# UNITED STATES PATENT AND TRADEMARK OFFICE

APPLICATION NO.	FILING DATE	FIRST NAMED INVENTOR	ATTORNEY DOCKET NO.	CONFIRMATION NO.
09/677,870	10/03/2000	Woo Hyuk Choi	2658-0240P	6124

## Office Action Summary

## **DETAILED ACTION**

FIG. 6

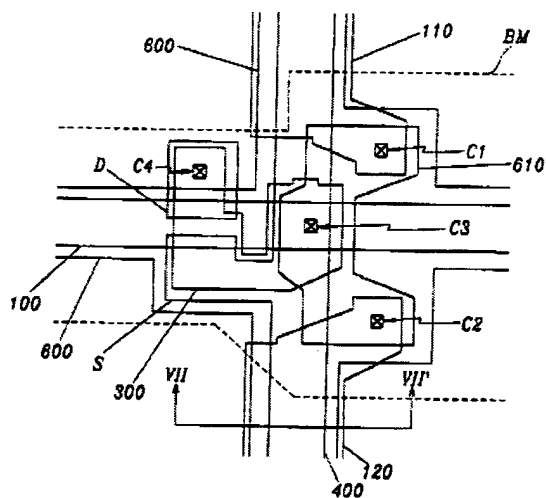
As to claims 1, 8, 10, 17, 21, 23, and 26-27, Kim discloses in the third embodiment, Figures 6 and 7, (col. 6, line 35 through col. 7, line 5), a thin film transistor substrate in a liquid crystal display substrate comprising: a data line, 400, for applying a data signal, a gate line, 100, for applying a gate signal, and an ITO [col. 5, lines 1-5] transparent pixel electrode, 600, for driving a liquid crystal cell, repair lines, 110 and 120, (Applicant's gate dummy pattern) formed of the same material layer as the gate line (col. 6, lines 38-42 and col. 2, lines 10-17) and formed parallel to said data line, 100, and to overlap the pixel electrode, 600, and data line 400, to compensate for misalignment occurring along the data line,

Wherein the gate dummy pattern is formed to overlap [L3 and L4] with an edge portion of the pixel electrode (per Figures 6 and 7), and is separated by gate insulating

layer, 200, thereby resulting in an aperture ratio increase of from about 5 to 6% per

**FIG. 13**

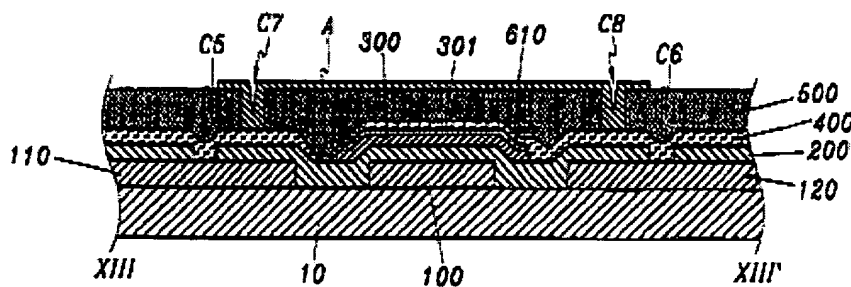
Kim teaches in Figure 13 wherein when the data line is broken, the use of forming holes and connections to the repair lines, 110 and 120, (Applicant's gate dummy pattern) and to a connecting pattern, 610, to repair a broken data line, 400, (col. 8, lines 1-15).

**FIG. 26**

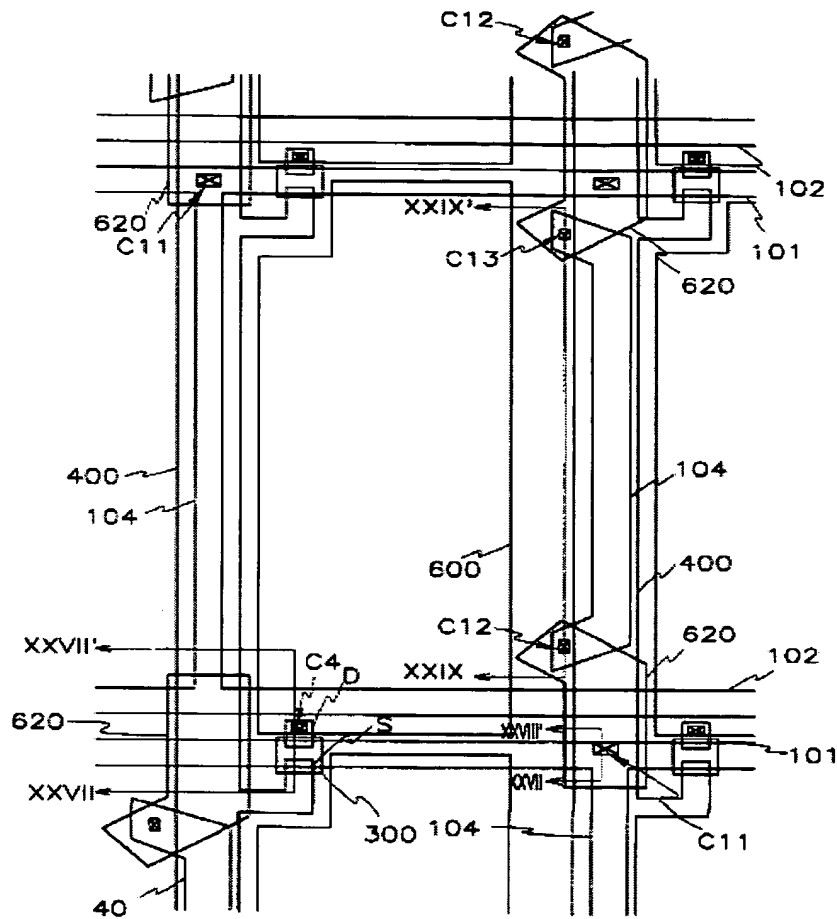
Kim teaches in Figure 26 the use of repair lines, 104, (Applicant's gate dummy pattern used as a redundancy electrode) to connect the gate line to the data line (col. 13, lines 4-17).

**FIG. 19A**

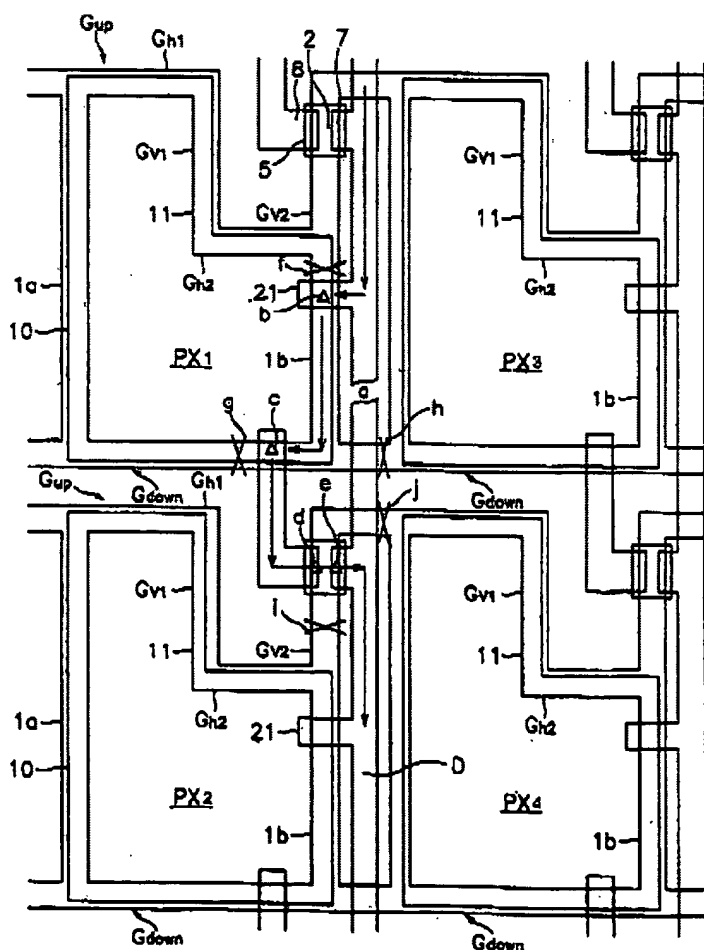
Song teaches 1) the use of a redundant pattern that is integrated with the gate line and branches from the gate line in Figure 19A ( $G_{up}$  and  $G_{down}$  or 1a and 1b) wherein a dummy pattern extends substantially the entire length of the pixel electrode portion adjacent and parallel to the data line [portion running under right edge of pixel electrode in Figure 19A from below  $Gv2$  to the horizontal portion between g and h] as a redundancy electrode for electrically connecting the gate line to the broken data line (col. 17, lines 4-67, especially col. 17, lines 47-54) to effect repairs.

Song teaches, wherein when the data line is broken, the use of a redundant pattern in Figure 19A ( $G_{up}$  and  $G_{down}$  or 1a and 1b) as a redundancy electrode for electrically connecting the broken data line (col. 17, lines 4-67, especially col. 17, lines 47-54) to effect repairs.

**FIG. 18**

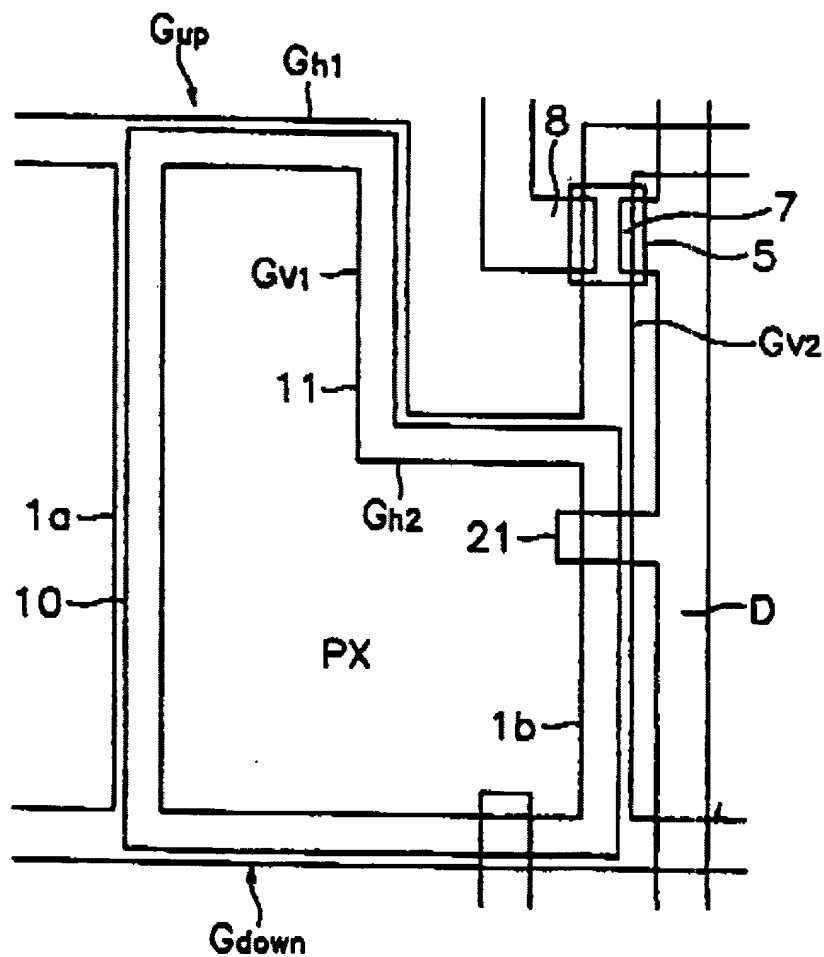
As to claims 6, 15, 22, and 24, and Song teaches in Figure 18 a thin film transistor substrate further comprising: a storage capacitor (col. 15, lines 56-64) defined by a horizontal overlapping part,  $G_{h2}$ , between the gate line and the pixel electrode, PX. Song also teaches in Figure 18 an analogous overlapping portion, 21, of the data line, D, to permit a repair. Also, any two conductors separated by an insulator result in a capacitor as a matter of physics. Therefore the overlap region between the pixel electrode and the dummy pattern which are separated by an insulator necessarily forms a capacitor.

As to claims 7 and 16, Song teaches in Figures 18 and 19A a protrusion, 21, protruded from the data line in such a manner to overlap with the intended repair site (Applicant's recess and narrowed portion of the gate dummy patterns), the structure of which would thereby shut off a light leaked between the gate dummy pattern and the gate line (col. 15, lines 42-63). Note that in considering the disclosure of a reference, it

*Fig.2 PRIOR ART*

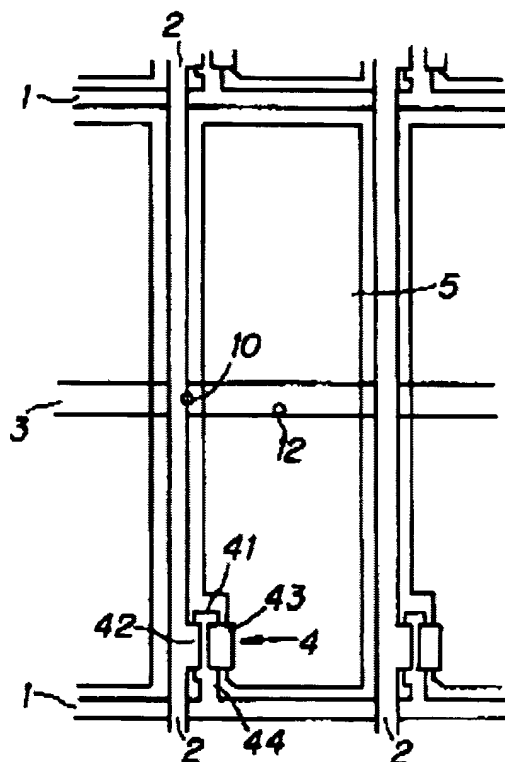
(5) It is respectfully pointed that recess is on the left side of the narrow part, 44, that leads to the gate electrode, 41, in Figure 2 below:

The teaching of Irie would be more than sufficient to render the use of a recess obvious to one having ordinary skill in the art at the time the claimed invention was made, and as evidenced by the prior art, would not be confusing with respect to the need for light blocking layers (no teaching away). One skilled in the art does not forget fundamentals (like light blocking) when incorporating an added feature (like a recess/narrowed portion). Examiner cannot see any reason to believe one of ordinary skill in the art would be mislead into creating an inoperable device based upon the combination of applied prior art. Examiner has considered all of Applicant's arguments
